Access Compliance Report

Public Rights-of-Way

(Curb Ramps)

Intersection ID: 46708	Main Street: REA_RD	Cross Street: BLAKENEY_PROFESSIONAL_DR	Location: NW
ADA ID: D83CA1F08C3A	Ramp Type: PerpDiag	Initial Pass/Fail: Fail	Overall Compliance: No
Severity Score: 10			
Codes/Mitigation Info/Possible Solution		Field Measurements/Component Compliance

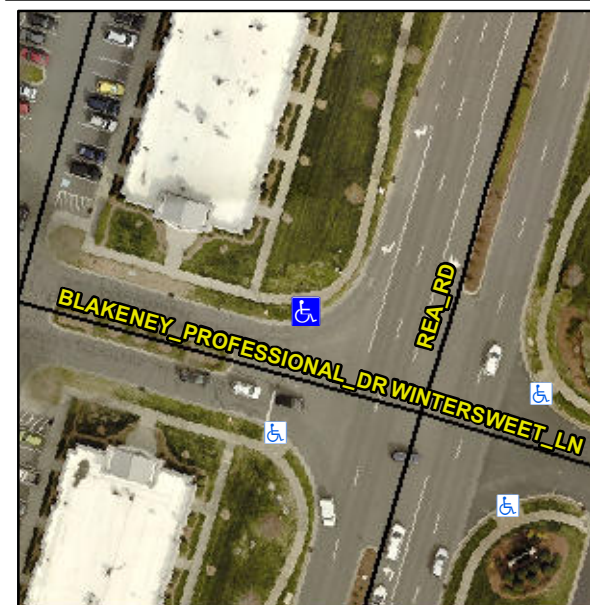
Not Found, R304.5.1, R304.5.3

Compliance	Description	Data	Compliance	Description	Data
N/A	Ramp Length (in)	87.0	Yes	Ramp Slope (%)	7.4
No	Ramp Width (in)	36.0	No	Ramp XSlope (%)	2.8
N/A	Flare Type LT	N/A	N/A	Flare Type RT	N/A
N/A	Flare Slope LT (%)	N/A	N/A	Flare Slope RT (%)	N/A
N/A	Flare Traversable LT?	N/A	N/A	Flare Traversable RT?	N/A
N/A	Landing Length (in)	N/A	N/A	DWS Provided?	N/A
N/A	Landing Width (in)	N/A	N/A	DWS Contrast?	N/A
N/A	Landing Slope (%)	N/A	N/A	DWS Length (in)	N/A
N/A	Landing X Slope (%)	N/A	N/A	DWS Full Width?	N/A
N/A	Landing Curb? (Y/N)	N/A	N/A	DWS Offset (in)	N/A
N/A	Shared Landing?	N/A			
N/A	Gutter Ponding?	N/A	N/A	Gutter Slope (%)	N/A
N/A	Gutter Lip Ht (in)	N/A	N/A	Gutter X Slope (%)	N/A
N/A	Painted X Walk1?	No	N/A	Painted X Walk2?	No
	X Walk 1 Direction	To SW		X Walk 2 Direction	To SE
N/A	X Walk 1 Width (in)	N/A	N/A	X Walk 2 Width (in)	N/A
	X Walk 1 Slope (%)	0.4		X Walk 2 Slope (%)	1.5
	X Walk 1 X Slope (%)	0.1		X Walk 2 X Slope (%)	1.8

Remove & Replace Curb Ramp With Two New Directional Ramps or Equivalent.
